Building 10N Package No: 12 3200-0007-0 Date: 06/04/2010

Bookstore Casework and Samples

College of San Mateo - CIP2 Project # 006169 1700 W. Hillsdale Blvd. San Mateo, CA 94402

Preparer Approval	McCarthy Approval
Spec Section Sub Section Item No Revision 12 3200 1.6.C 2,220 0 Bookstore Casework Shop Drawings and Samples Approved for Submission By: Ted Baylis Franklin Fixtures Inc	This review is for general conformance with Plans and Specifications only. Any deviations from same not clearly noted by the Preparer have not been reviewed. Review shall not constitute a complete check of detailed dimensions or count or serve to relieve the Preparer of contractual responsibility for any error or deviation from contract requirements. By: Mary Chan Date: 06/04/2010 Submittal Package No: 12 3200-0007-0
	Bookstore Casework and Samples
LPA Inc Approval	Engineer Approval
1548 Eureka Rd Suite 101 Roseville, CA 95661 Review and commentary noted below are only for general conformance with (1) the design concept of the project and (2) the information given in the contract documents and for no other purpose. Commentary below is subject to the requirements of the contract documents. The Contractor

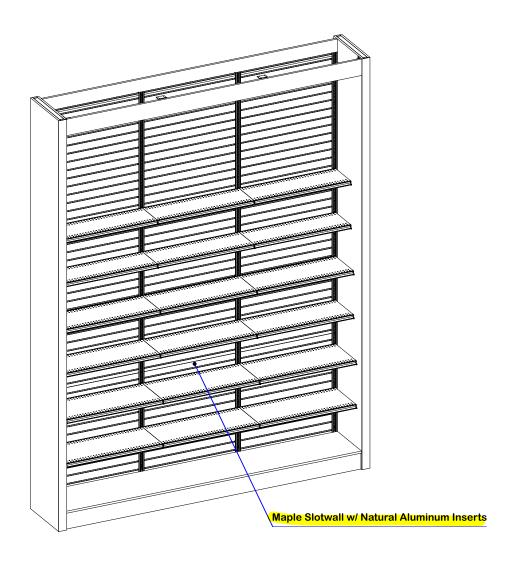
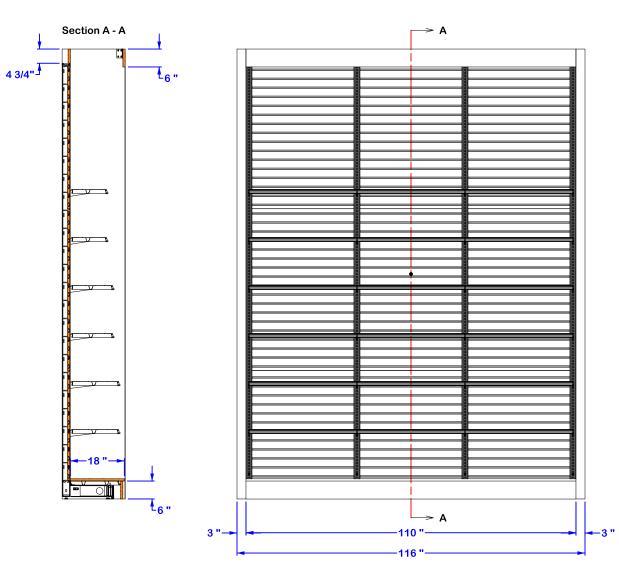
These values in the chart do not coordinate with the plan for items C(1) C(2). Item F should be built to fit Architectural opening of wall. All locations must be field verified to fit.

Madix Installation 'Y2'
SiProjected/Customers Name, Location, Proport #San Mateo
Wt: 382 lbs Sheet 1/1

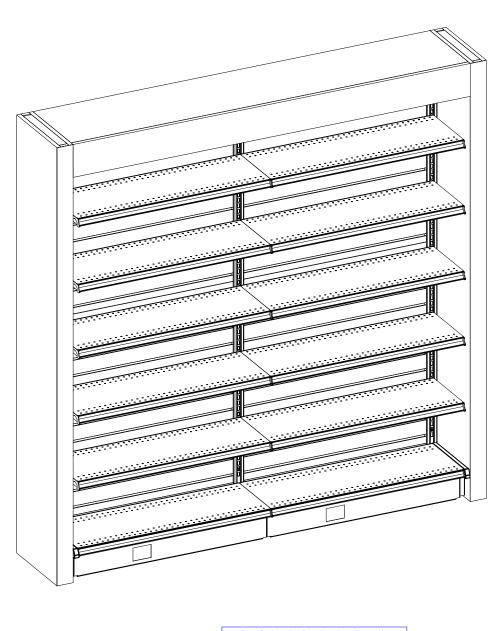
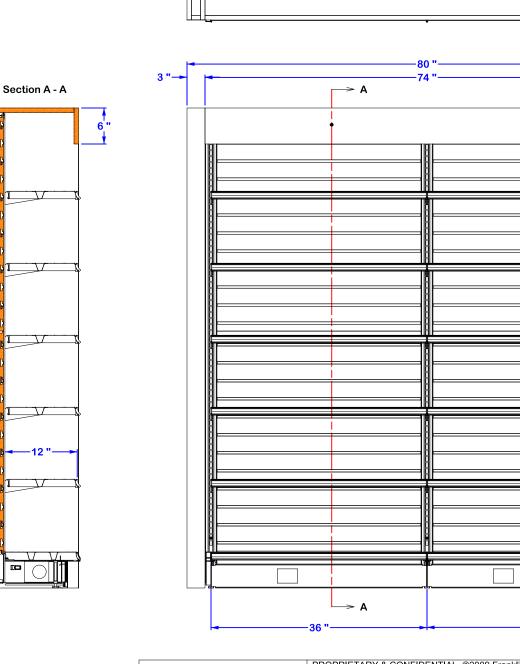
Finish in C-store to be Hardrock Maple Plastic Laminate, not clear where the "Z" item is located by plan.

Top to align with bottom of soffit
